CT-CONTACT-RET-001-A / REAR CONTACT RETENTION

Geometric prototype. Internal wire routing, factory process and physical qualification remain open.

CHANGED / DIMENSIONS IN mm

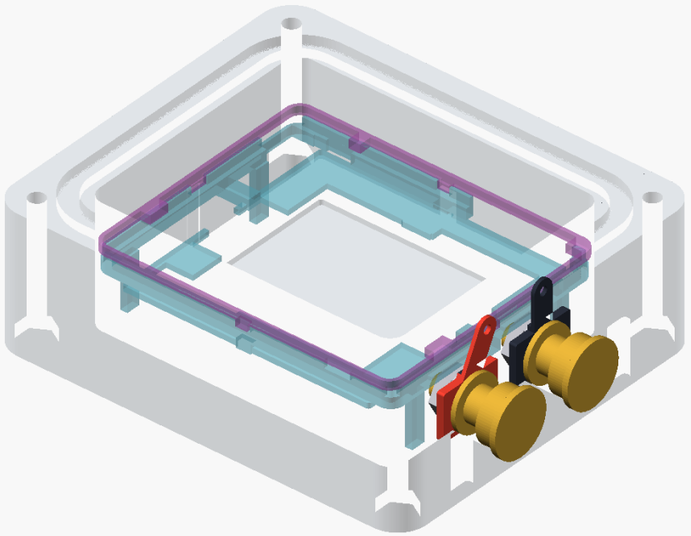
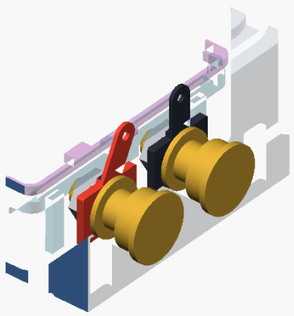
r16 / unchanged outside size; new dry-side bearing pockets

r16 / custom terminals, washer and M3 thin nut

Old 6.4mm circular stack is smaller than the bore.

New plate bears on both sides of the 7.34mm bore.

Minimum calculated ear bearing: 4.413mm2 each.

All 85 swept populated envelopes clear new metal.

Minimum component gap: 2.146mm at C10.

Head, seal glands and dock contact locations retained.

PCB/Gerber unchanged: both actual JLC runs 0/0/455.

Torque, pull, resistance, plating, creep and water/dust tests remain open. No supplier enquiry or order was sent.

Bearing faces: case X=22.60 +/-0.05.

Contact stem: 5.90 +/-0.05; M3 x 0.5 thread: 4.80.

Terminal base: 9.0 wide; Z=2.35 to 8.65; 1.0 thick.

Tail: 0.50 thick above Z=9.25; 1.20 wire hole.

Positive tail: Y=-3.30, Z=13.30; red to J3.1.

Ground tail: Y=+6.00, Z=13.30; black to J3.2.

Washer HRDW-M3-A2 / nut HFN-M3-A2 candidates.

Custom machined terminals; use contact.json and contacts.scad. Not a purchased Keystone lug or a plastic printed part.
